Historic Zoning Commission

February 20, 2025

Old Business

Case # HZ-24-128

① EXISTING ROOF PLAN
1/8" = 1'-0"

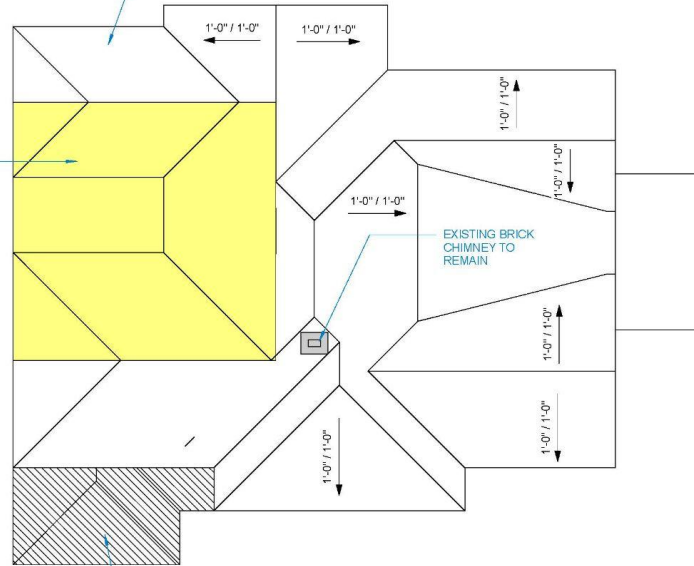
YELLOW INDICATES AREA
OF MODIFICATIONS TO
ROOF FOR NEW 2ND
FLOOR ADDITION

MAINTAINING ORIGINAL ROOFLINE MAKES ADDITION
AT REAR LARGELY HIDDEN FROM FRONT CORNER
OF HOUSE
